Strathfield Internal Development Assessment Panel Meeting

DA2019/185 - 56 Homebush Road, Strathfield - Lot A DP 1696633

TO: Strathfield Internal Development Assessment Panel Meeting - 12 June 2020
REPORT: IDAP – Report No. 1
SUBJECT: DA2019/185 - 56 HOMEBUSH ROAD, STRATHFIELD - LOT A DP 169663
DA NO. DA2019/185

Figure 6: Original north elevation excavation (outlined in blue)

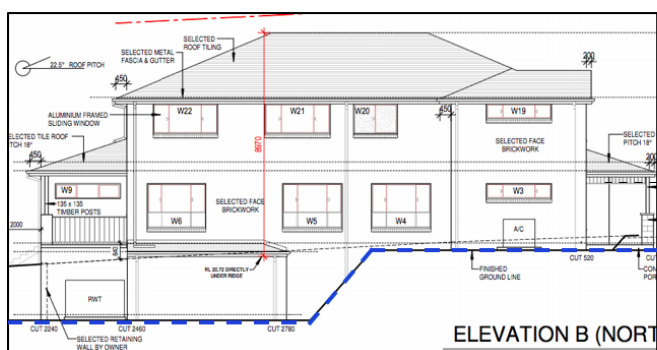
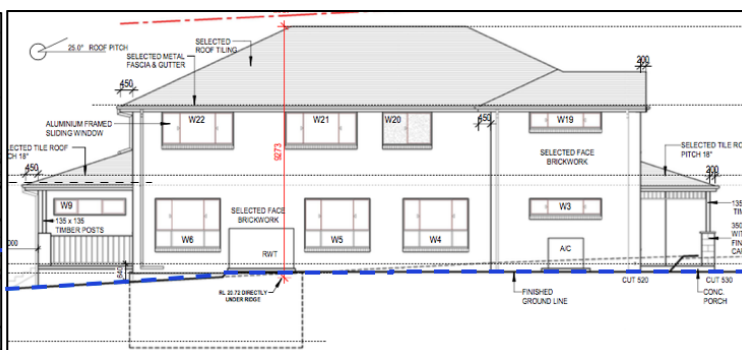
During the assessment process, concerns were raised for the excessive amount of cut proposed for the dwelling and basement entry in particular. Amended plans were submitted in response to these concerns which significantly reduced the amount of cut along the north elevation of the dwelling (Figure 6 and 7). The rear portion of the driveway was also deleted and replaced with landscaping on natural ground level (Figure 8 and 9). The size of the basement was also reduced to be contained within the footprint of the ground floor above. Whilst it is noted that excavation is proposed within the minimum side setbacks along the southern side boundary, this excavation is limited to the driveway only. Appropriate conditions of consent will be imposed to minimise the disruption of soils for both the subject site and neighbouring properties. The amount of excavation proposed is no longer considered to be excessive and the provisions of the Clause are considered to be satisfied.

Figure 7: Revised north elevation excavation (outlined in blue)

Figure 11: Original driveway plan

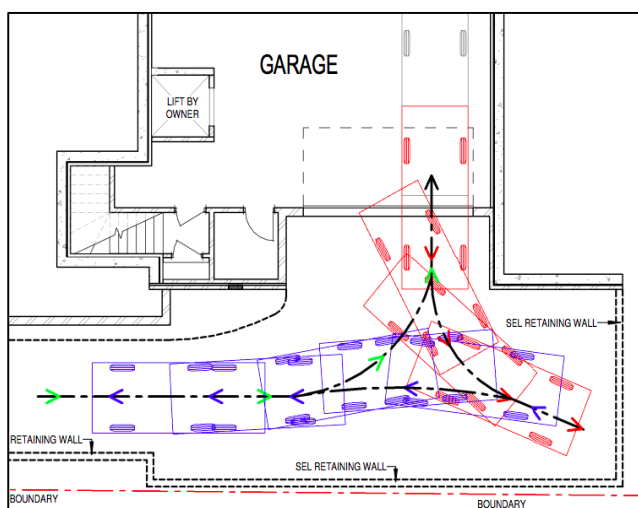
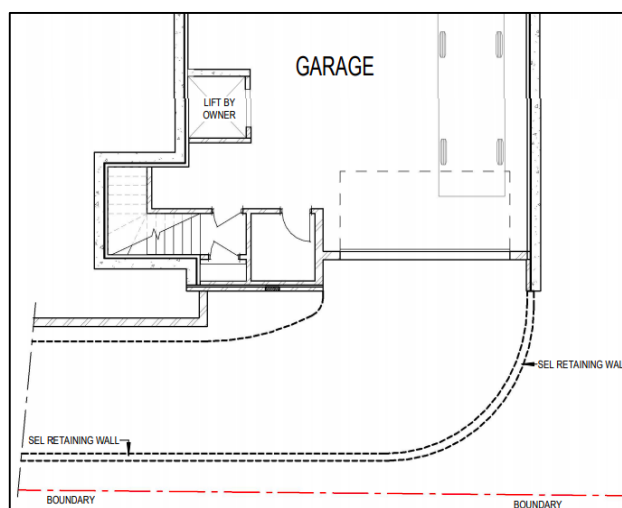
The Internal Development Assessment Panel raised concerns for the long and straight appearance of the proposed driveway design along with the nil setback of the driveway from the southern side boundary. Following the IDAP meeting, the applicant submitted an amended driveway plan, with a curved entry design, a reduced overall length (from 36.47m to 31.36m) and an increased side setback of 700mm from the southern side boundary (Figures 11 and 12). The 700mm driveway setback from the southern side boundary will provide opportunity for landscaping within this setback area. This additional landscaped area, together with the curved driveway design will soften the overall appearance of the driveway entry and reduce its lengthy appearance from the street. Relevant conditions will be imposed to minimise site disturbance to the southern adjoining property. The height of the driveway retaining walls will also be restricted to the existing ground level by a condition in the consent.

Figure 12: Amended driveway plan
